ATTACHMENT I

PROPOSED TECHNICAL SPECIFICATIONS CHANGES

POWER AUTHORITY OF THE STATE OF NEW YORK
INDIAN POINT 3 NUCLEAR POWER PLANT
DOCKET NO. 50-286

Section I - Description of Modification to the Technical Specifications

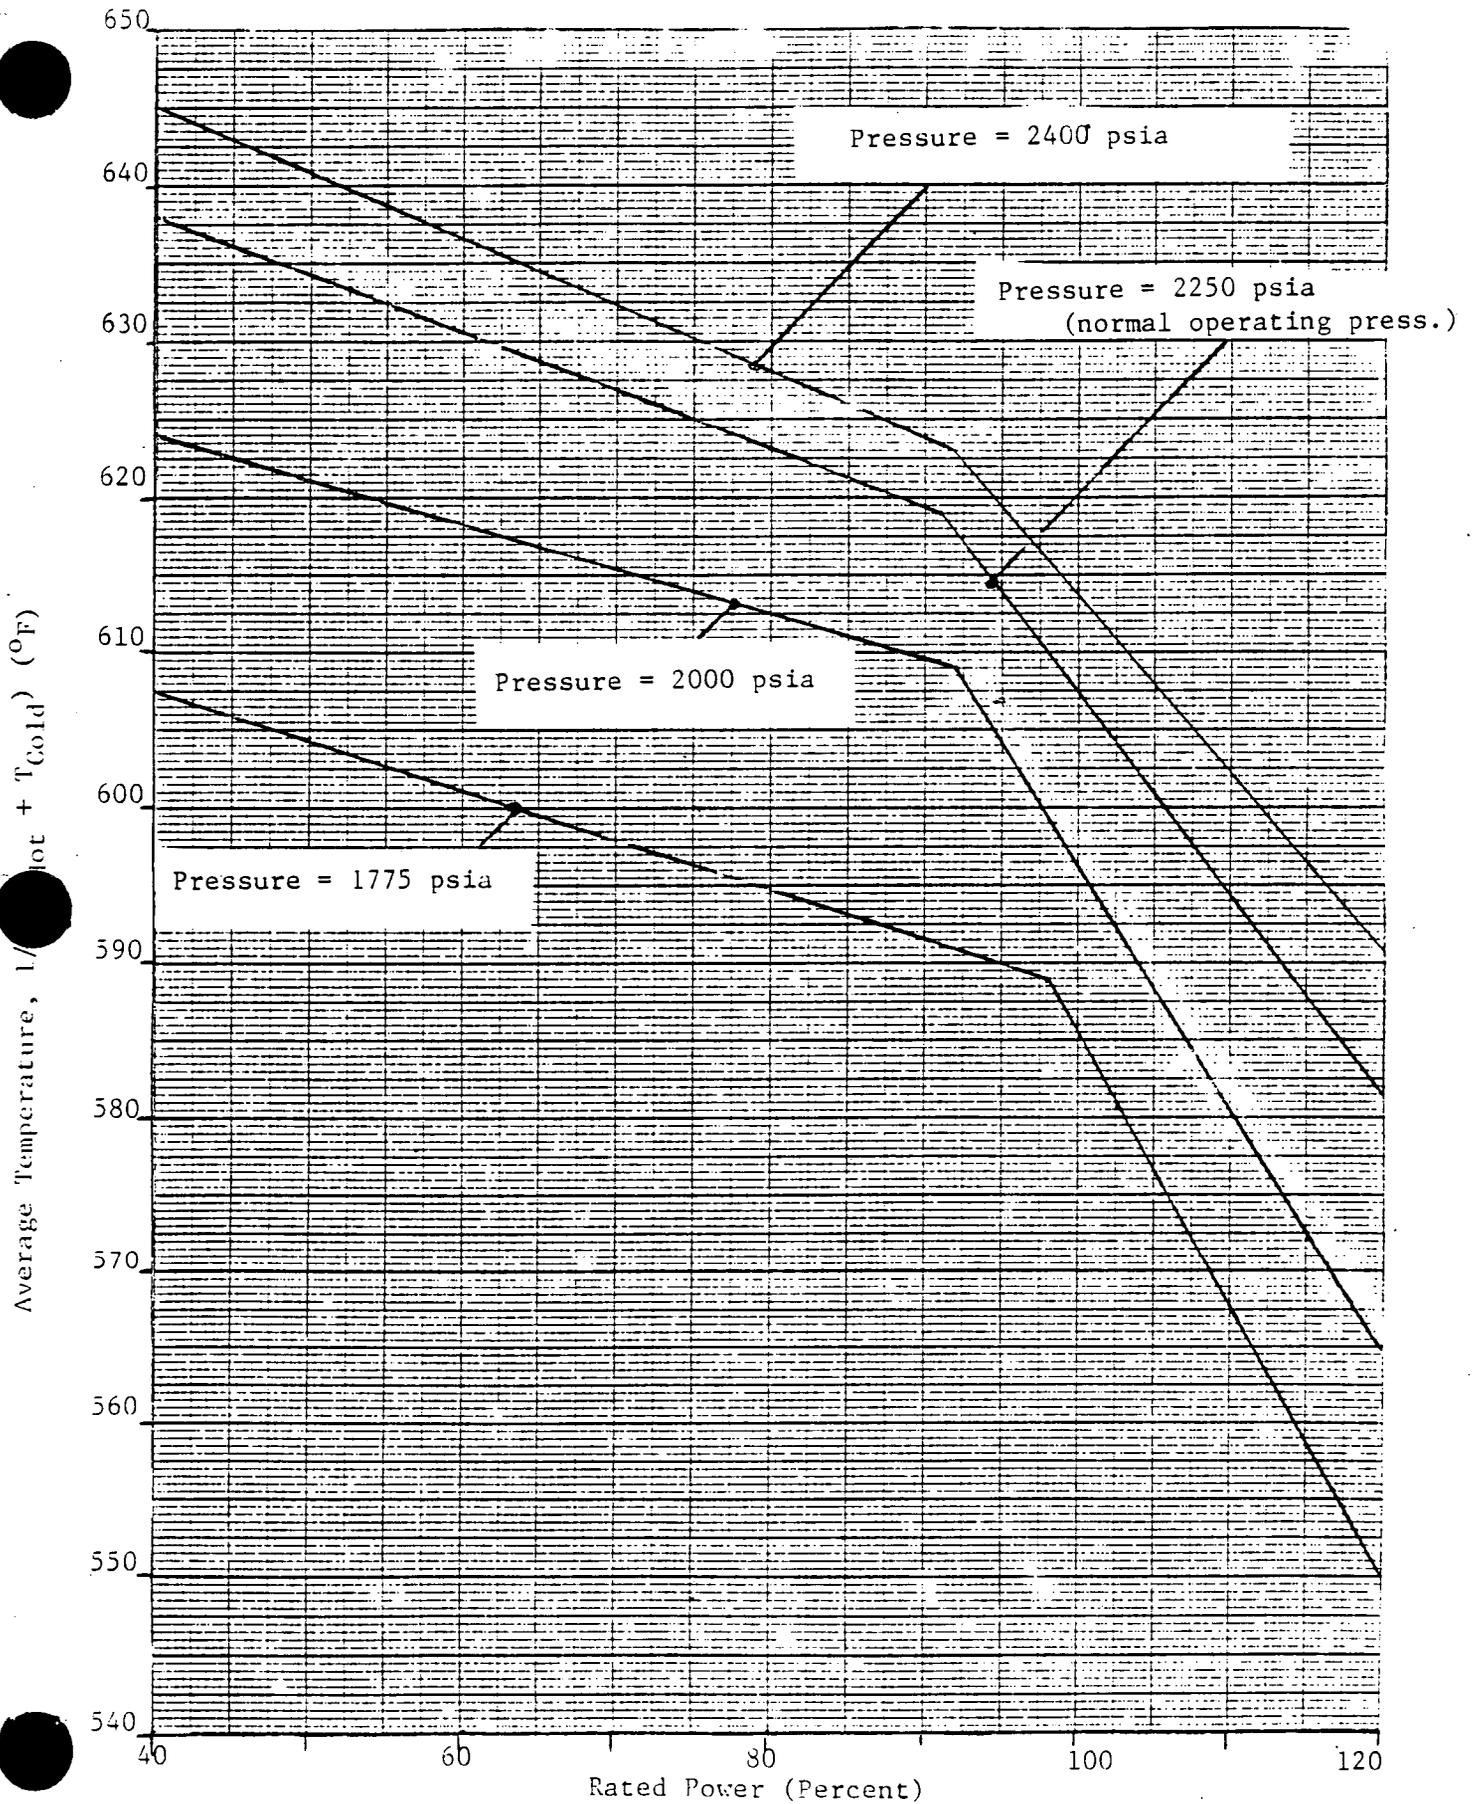
The combination of thermal power level, coolant pressure, and coolant temperature shall not exceed the limits shown in Figure 2.1-1 for four-loop operation. The safety limit is exceeded if the point defined by the combination of Reactor Coolant System average temperature and power level ~~is at any time above the appropriate pressure line.~~

The curves of Figure 2.1-1 represent the loci of points of thermal power, coolant system pressure and average temperature for which the DNBR is no less than 1.30. The area where clad integrity is assured is below these lines.

The calculation of these limits includes an $F_{\Delta H}^N$ of 1.55, DNB penalties for increased pellet eccentricity, local power spikes, 8% uncertainty in $F_{\Delta H}^N$, up to 24% steam generator tube plugging, and a reference cosine with a peak of 1.55 for axial power shape.⁽³⁾

Figure 2.1-1 includes an allowance for an increase in the enthalpy rise hot channel factor at reduced power based on the expression:

The proposed changes to the Technical Specifications are shown in Attachment I. Sections 2.1, 2.3, 3.1 and 3.10 of the Technical Specifications have been revised. These proposed changes delete references to three loop operation and incorporate the results of a recent ECCS reanalysis which modifies the reactor core limits.

The purpose of the modification is to revise the IP-3 Technical Specifications so as to comply with the ECCS reanalysis for up to 24% steam generator equivalent tube plugging. References to three loop operating have been deleted from the Technical Specifications since IP-3 is restricted to 10% power or less for less than four loop operation.
